## 12/30/16

**2016.12.December / Basement / Area A -**

## 2016.12.December / Floor 01 / Area A -

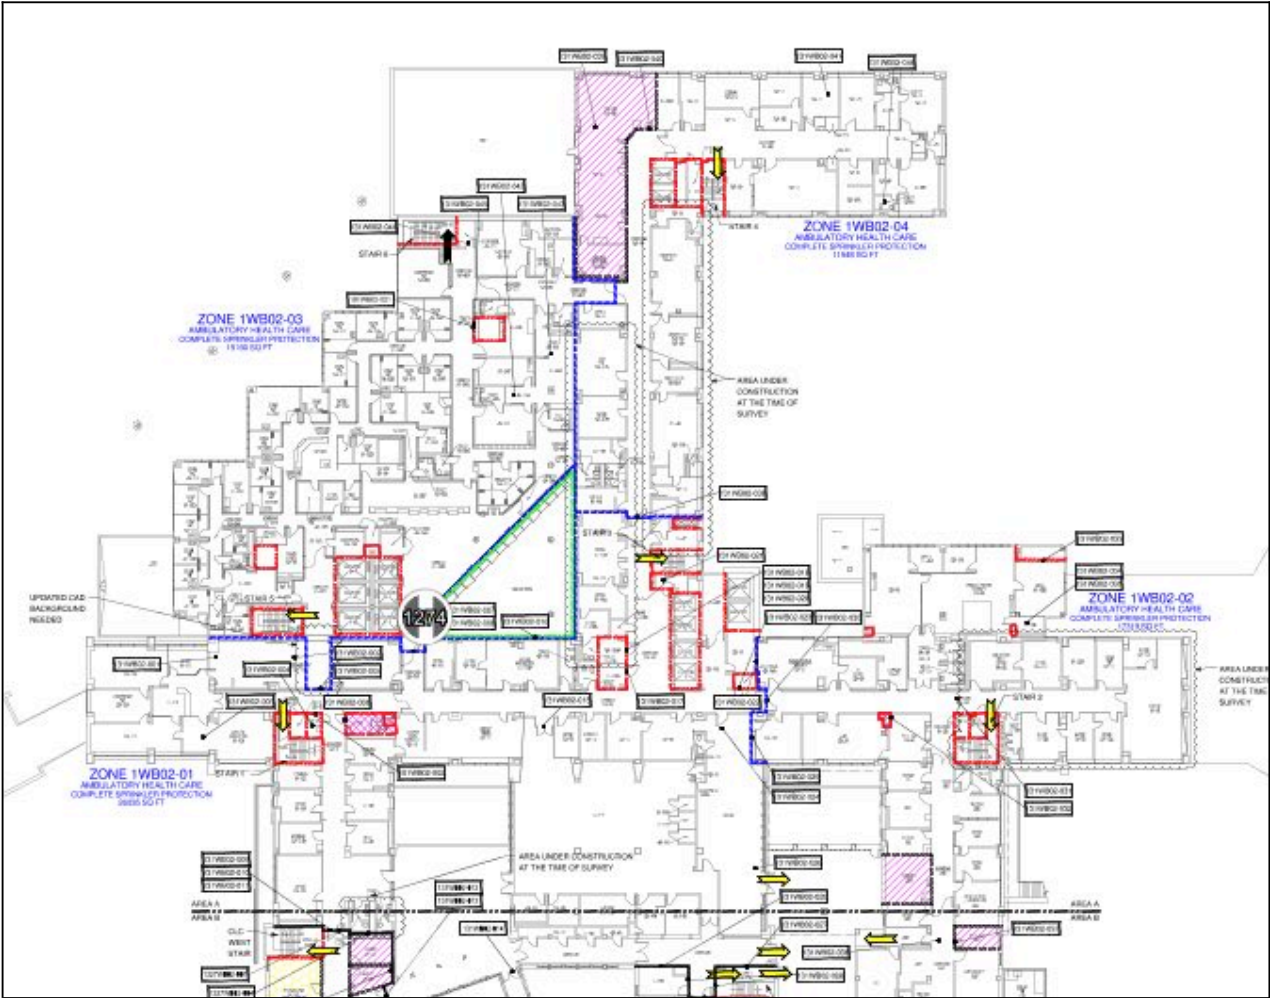
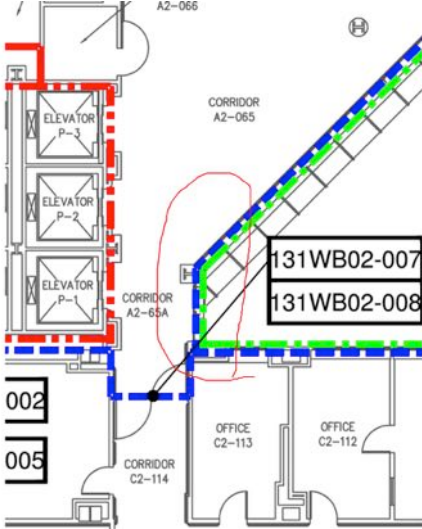
Date Created	EOCS ID #	Punch #	Full Plan View	Room Number	Item	Type	Wall Material	Fire Rating	Comments
3/28/16	306125	1168	2016.12.December / Floor 01 / Area A	N1-144	Large Opening	Large wall with penetrations	Concrete	1 Hour Smoke Zone Barrier	7'x2' gypsum repair, studs already in place, dod:2 previously under construction last inspection
<div>   </div> <div> <div>3/28/16 07:18 AM</div> <div>10/3/16 09:00 AM</div> </div>									
6/10/16	325101	1290	2016.12.December / Floor 01 / Area A	Electrical room next to elevator lobby	Large Opening	Large wall with penetrations	Concrete	2 Hour	Deteriorating block with penetrations. 4ft x 2ft. DOD 10 due to mechanicals interfering. previously under renovation

Date Created	EOCS ID #	Punch #	Full Plan View	Room Number	Item	Type	Wall Material	Fire Rating	Comments
<div>   </div> <div> <div>6/10/16 09:08 AM</div> <div>6/10/16 09:09 AM</div> </div> <div>   </div> <div> <div>6/10/16 09:11 AM</div> <div>6/10/16 09:12 AM</div> </div>									
6/10/16	325130	1291	2016.12.December / Floor 01 / Area A	C1-77	Large Opening	Large wall with penetrations	Concrete	Smoke Barrier Zone	1.5ft x 1.5ft DOD 5. previously under renovation
<div>  </div> <div> <div>6/10/16 09:32 AM</div> </div>									
6/10/16	325133	1292	2016.12.December / Floor 01 / Area A	C1-77	Large Opening	Large wall with penetrations	Concrete	Smoke Barrier Zone	1.5ft x 1.5ft. DOD 5. previously under renovation

Date Created	EOCS ID #	Punch #	Full Plan View	Room Number	Item	Type	Wall Material	Fire Rating	Comments
<div></div> <div>6/10/16 09:34 AM</div>									
9/8/16	343846	1412	2016.12.December / Floor 01 / Area A	A1-31B	Large Opening	Sections of walls missing	Gypsum	1 Hour	1'x1' section of drywall missings, DOD4
<div></div> <div>9/8/16 12:43 AM</div>

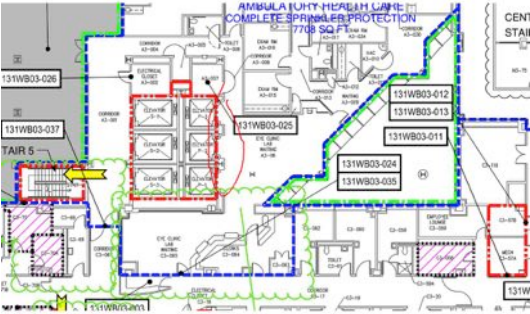
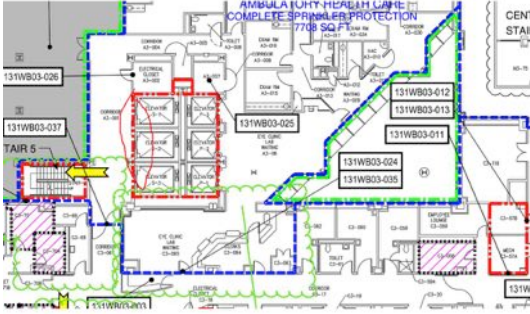
Date Created	EOCS ID #	Punch #	Full Plan View	Room Number	Item	Type	Wall Material	Fire Rating	Comments
6/8/16	324722	1274	2016.12.December / Floor 02 / Area A	Near double door. Atrium side.	Large Opening	Large wall with penetrations	Gypsum	1 Hour Smoke Zone Barrier	Section of drywall missing. Not built of to deck. DOD 4
<div><div><p>6/8/16 09:43 AM</p></div><div><p>6/8/16 09:44 AM</p></div><div><p>6/8/16 02:50 PM</p></div></div>

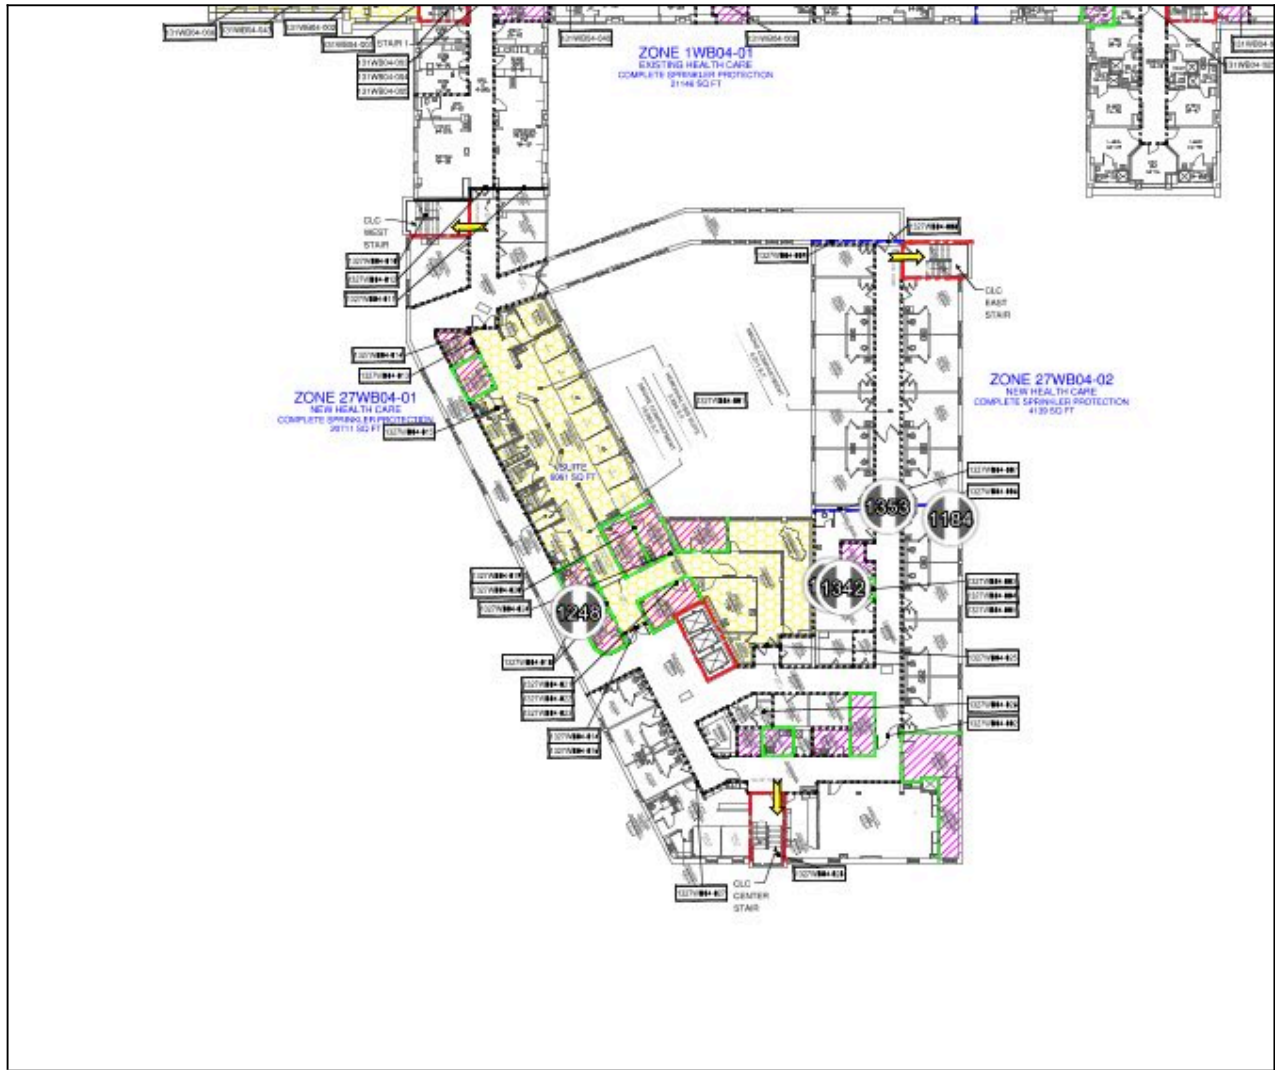
Date Created	EOCS ID #	Punch #	Full Plan View	Room Number	Item	Type	Wall Material	Fire Rating	Comments
			 <p>6/7/16 09:01 AM</p>						
6/7/16	324702	1266	2016.12.December / Floor 03 / Area A-Reno 5/31/16	Blue Elevator Lobby	Large Opening	Joints	Gypsum	2 Hour	HOW 26ft x 1inch Needs Stuffed and Sprayed
			<div>   </div> <div> <p>6/7/16 01:28 PM</p> <p>6/7/16 01:28 PM</p> </div> <div>  <p>6/7/16 01:32 PM</p> </div>						
6/7/16	324705	1267	2016.12.December / Floor 03 / Area A-Reno 5/31/16	A3-001	Large Opening	Joints	Gypsum	2 Hour	HOW 30ft x 3inches Already Stuffed Needs Sprayed

Date Created	EOCS ID #	Punch #	Full Plan View	Room Number	Item	Type	Wall Material	Fire Rating	Comments
<div>   </div> <div> <div>6/7/16 01:34 PM</div> <div>6/7/16 01:35 PM</div> </div>									
6/7/16	324706	1268	2016.12.December / Floor 03 / Area A-Reno 5/31/16	C3-17A	Large Opening	Joints	Gypsum	2 Hour	HOW 20ft x 1inch. previously under renovation
<div>   </div> <div> <div>6/7/16 01:39 PM</div> <div>6/7/16 01:39 PM</div> </div>									
9/2/16	343356	1375	2016.12.December / Floor 03 / Area A-Reno 5/31/16	C3-119 and C3-61	Large Opening	Joints	Concrete	Smoke Barrier Zone	30' HOW DOD-4
<div>   </div> <div> <div>9/2/16 04:25 PM</div> <div>9/2/16 04:27 PM</div> </div>									
9/3/16	343441	1394	2016.12.December / Floor 03 / Area A-Reno 5/31/16	C3-64	Large Opening	Sections of walls missing	Gypsum	1 Hour	4x3 DOD 5

Date Created	EOCS ID #	Punch #	Full Plan View	Room Number	Item	Type	Wall Material	Fire Rating	Comments
<div>  </div> <div> <div>9/3/16 01:53 PM</div> <div>9/3/16 01:54 PM</div> </div>									
9/3/16	343442	1395	2016.12.December / Floor 03 / Area A-Reno 5/31/16	C3-64	Large Opening	Sections of walls missing	Gypsum	1 Hour	2x2 DOD 1
<div>  </div> <div>9/3/16 01:59 PM</div>

## 2016.12.December / Floor 04 / Area B -

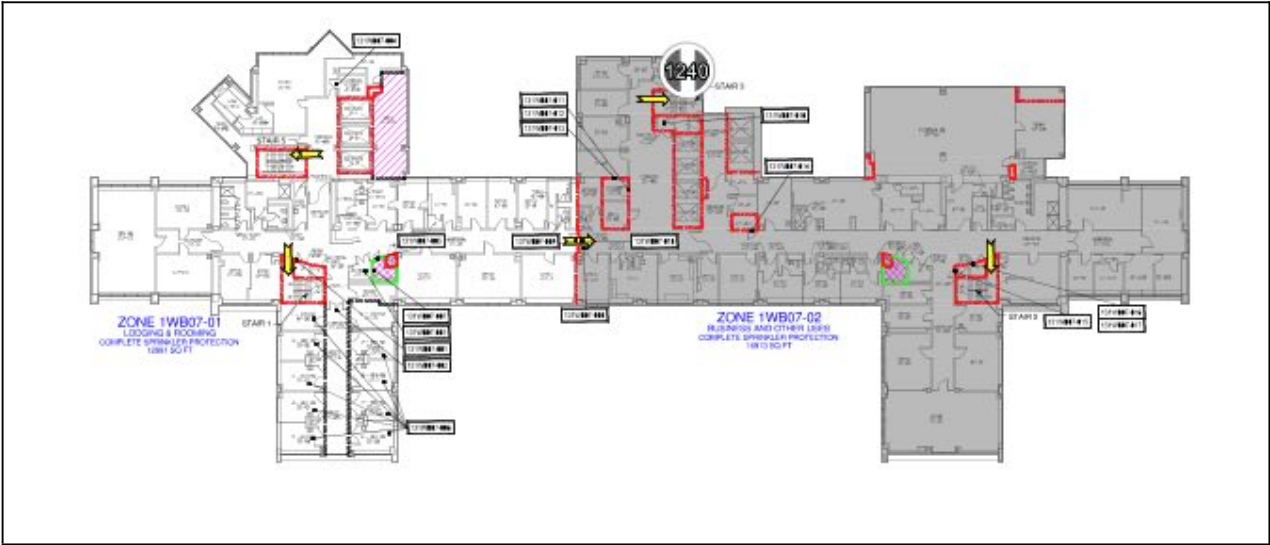
Date Created	EOCS ID #	Punch #	Full Plan View	Room Number	Item	Type	Wall Material	Fire Rating	Comments
3/31/16	306557	1181	2016.12.December / Floor 04 / Area B	Break Room	Large Opening	Joints	Gypsum	1 Hour	10' HOW With multiple penetrations dod 2 Recently rentivated
 <p>3/31/16 09:26 AM</p>									
3/31/16	306560	1184	2016.12.December / Floor 04 / Area B	Family Lounge- 4-158	Large Opening	Joints	Gypsum	1 Hour	20' HOW with multiple penetrations DOD 4 recently rentivated

3/31/16 09:36 AM									
6/6/16	324253	1248	2016.12.December / Floor 04 / Area B	4-122	Large Opening	Joints	Gypsum	1 Hour	4ft x 3inches DOD 2 Needs Stuffed and Sealed

6/6/16 12:58 PM					6/6/16 12:58 PM				
9/1/16	343181	1342	2016.12.December / Floor 04 / Area B	Storage left of 4-139	Large Opening	Sections of walls missing	Gypsum	1 Hour	10ft x 3ft DOD 10 Very difficult to install drywall due to mechanicals in the way

9/1/16 08:51 AM	9/1/16 08:52 AM					
9/1/16	343204	1353	2016.12.December / Floor 04 / Area B	Double Door by 4-141	Large Opening	Sections of walls missing	Gypsum	Smoke Barrier Zone	Smoke Barrier wall is not built to deck 8ft x 4ftft DOD 8 Very Difficult due to mechanicals

2016.12.December / Floor 07 -

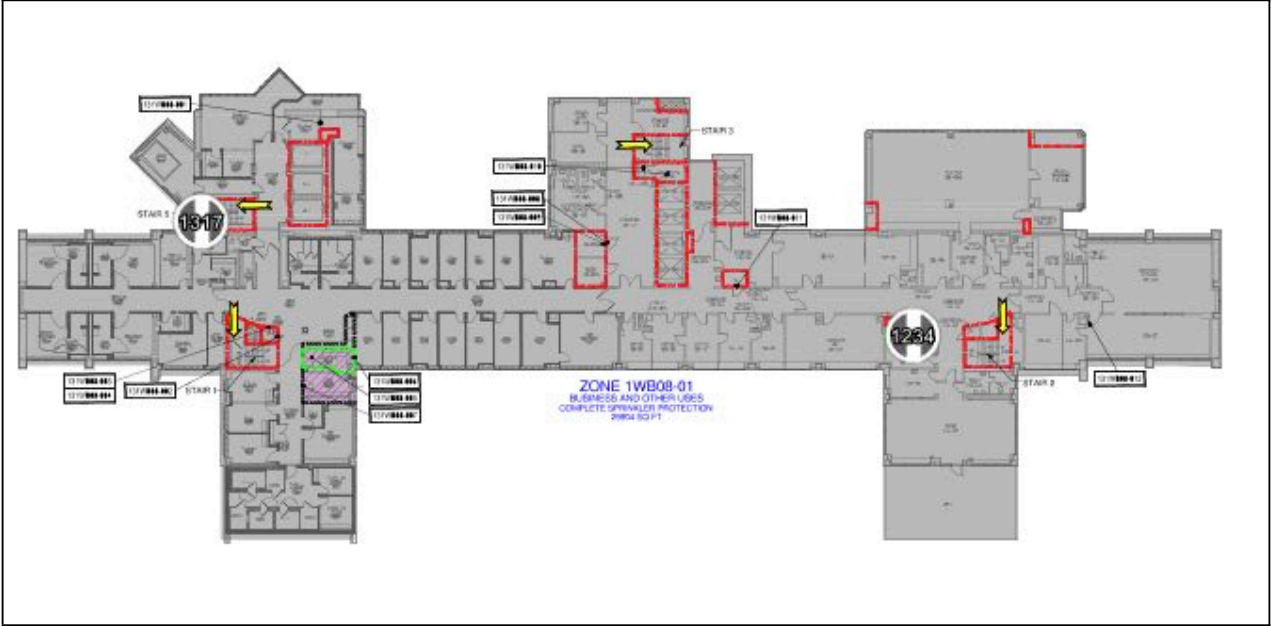
Date Created	EOCS ID #	Punch #	Full Plan View	Room Number	Item	Type	Wall Material	Fire Rating	Comments
6/3/16	324412	1240	2016.12.December / Floor 07	C7-49	Large Opening	Sections of walls missing	Concrete	2 Hour	(2) 3ft x 4ft openings. Old elevator shaft. Needs sealed.

2016.12.December / Floor 08 -

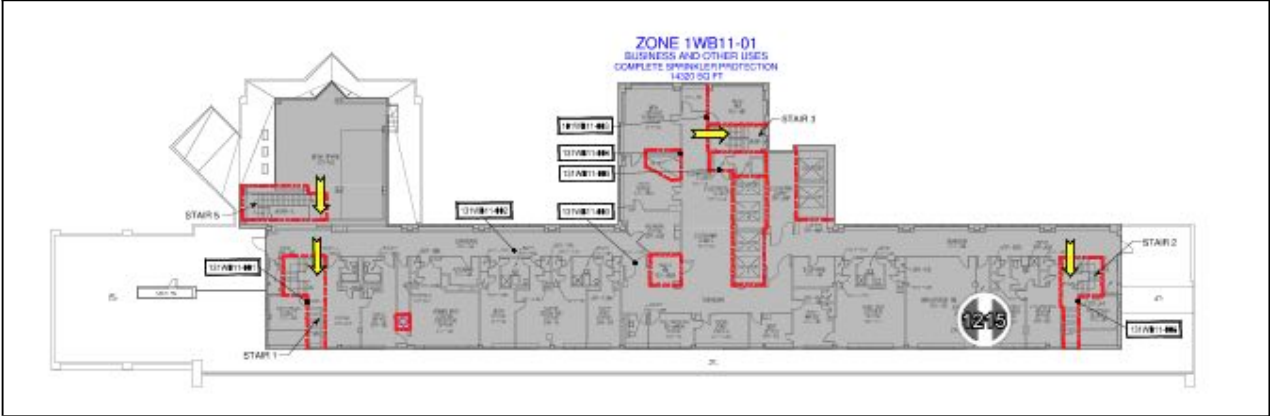
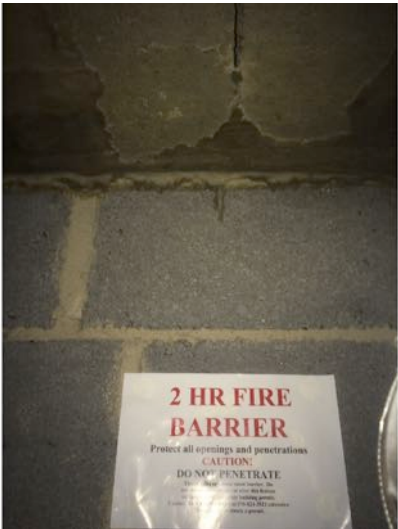
Date Created	EOCS ID #	Punch #	Full Plan View	Room Number	Item	Type	Wall Material	Fire Rating	Comments
6/2/16	323775	1234	2016.12.December / Floor 08	C8-33	Large Opening	Joints	Concrete	1 Hour	HOW 10ft x 4inches

8/30/16	341247	1317	2016.12.December / Floor 08	C8-21	Large Opening	Joints	Gypsum	2 Hour	8ft x 3inches Needs Stuffed and Sealed
---------	--------	------	-----------------------------	-------	---------------	--------	--------	--------	--
